PREVOST

**WARRANTY
 BULLETIN**

Wb05-04

DATE : APRIL 2005	SECTION : 01 - Engine
EXPIRATION: APRIL 2007	
SUBJECT : ENGINE HARNESSES SUBJECT TO TURBOCHARGER HEAT

FIGURE 1: MOVE TWO HARNESSES

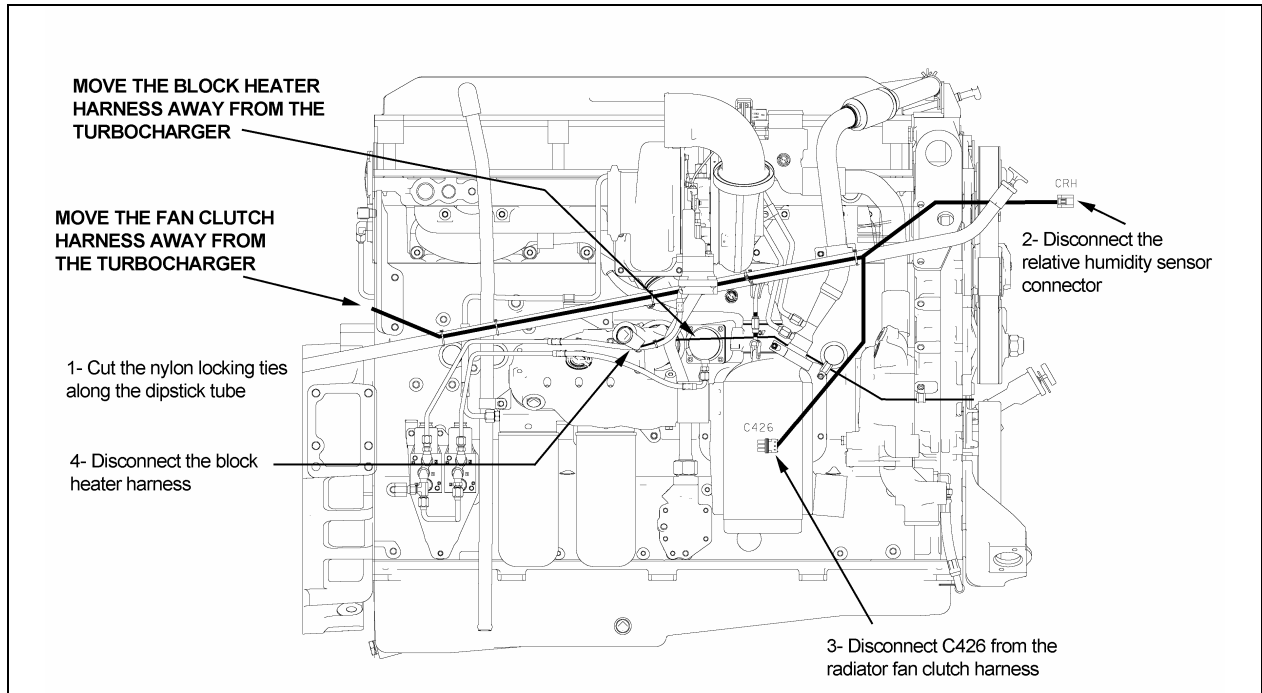
In order to meet the new EPA exhaust emissions regulations, Detroit Diesel has made modifications to engines. The engines produce 30% more heat. Consequently, two wire harnesses are more subject to heat emitted by the turbocharger. On the above mentioned vehicles, it is necessary to move these two harnesses away from the turbocharger.

1. Move the block heater harness and the radiator fan clutch harness as described in figure 1.

FIGURE 2: REROUTING THE HARNESSES

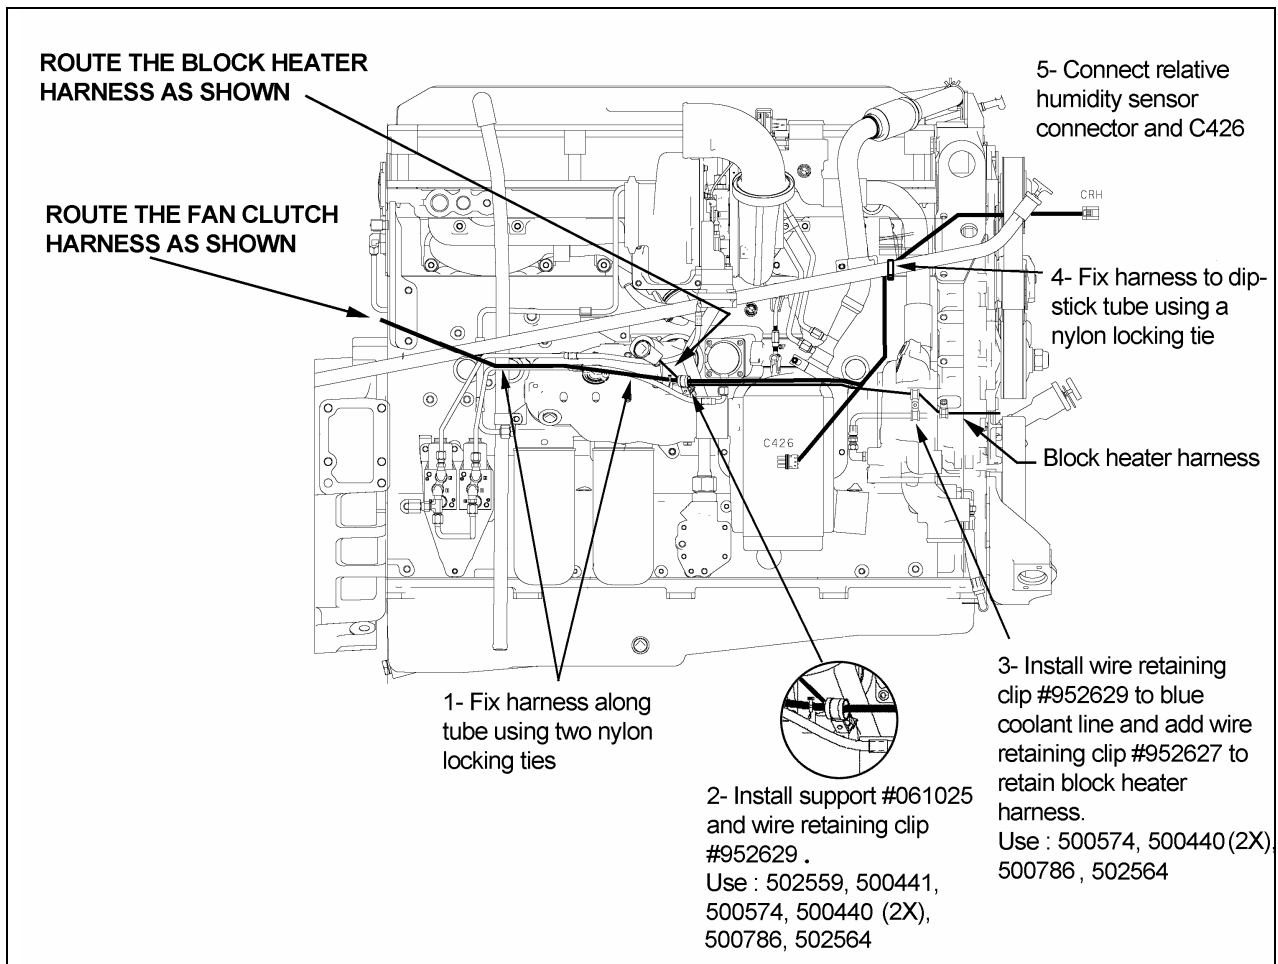
2. Reroute both harnesses as described in figure 2.

FIGURE 3: MOVE TWO HARNESSES

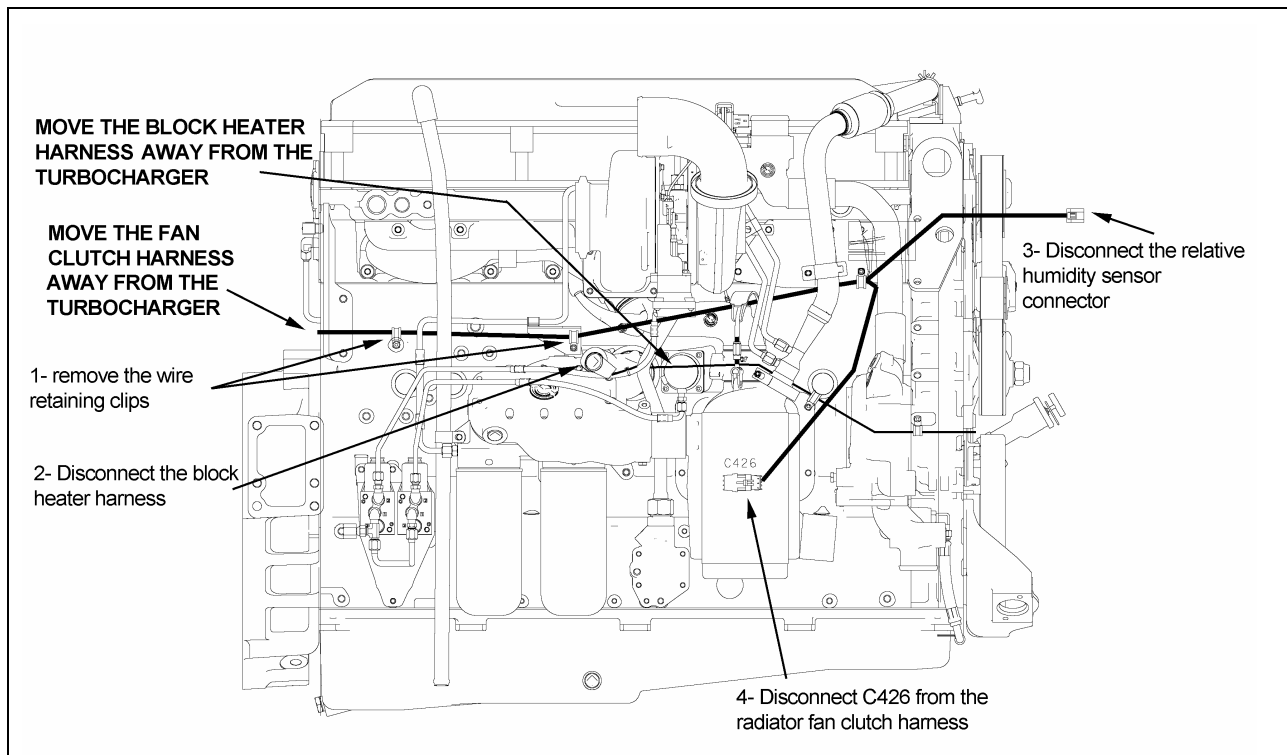
1. Move the block heater harness and the radiator fan clutch harness as described in figure 3.

FIGURE 4: REROUTING THE HARNESSES

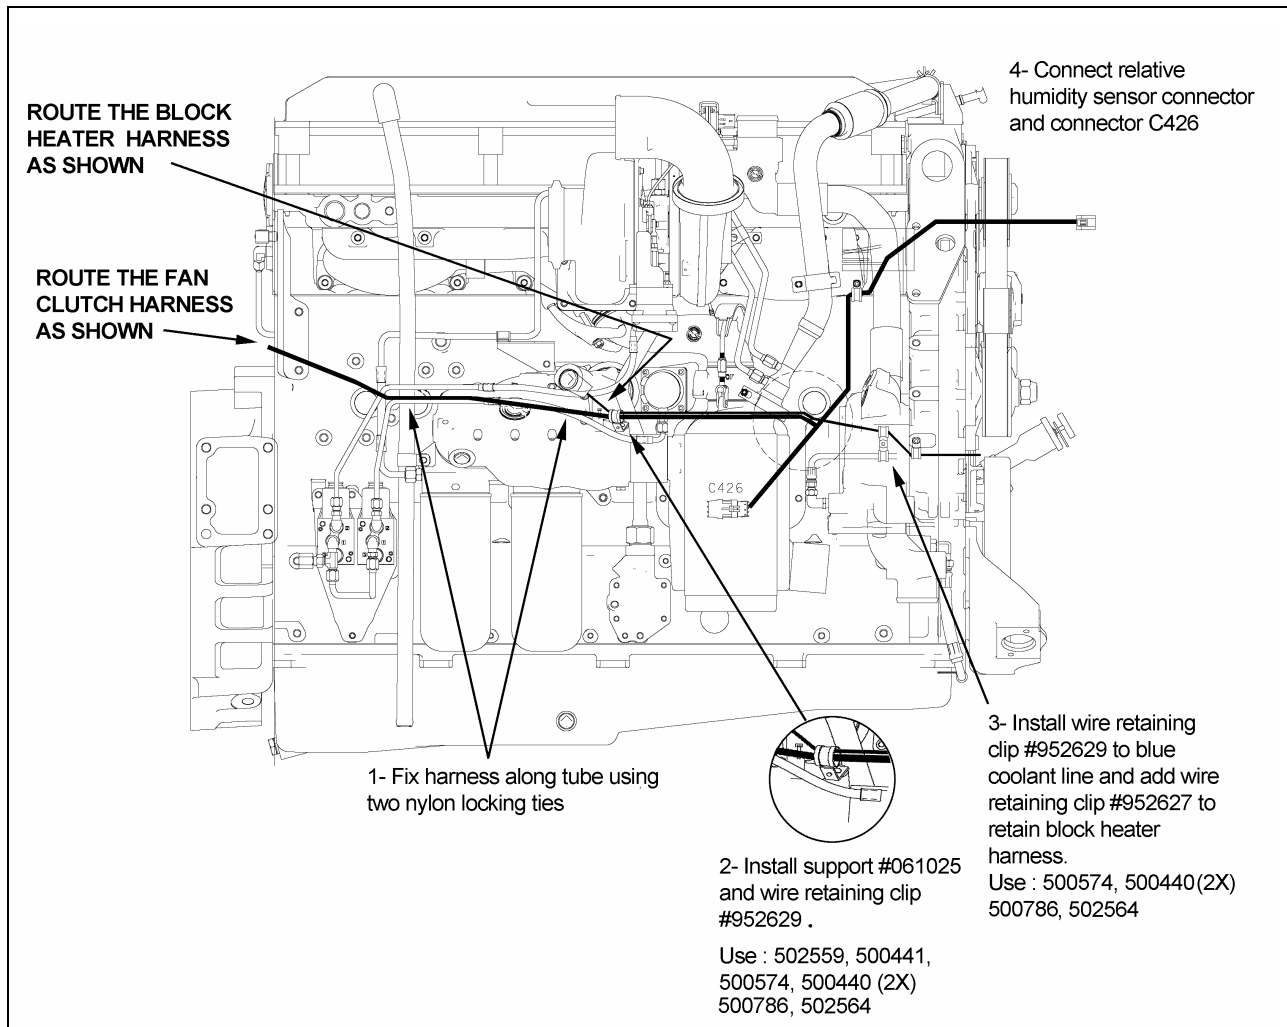
2. Reroute both harnesses as described in figure 4.
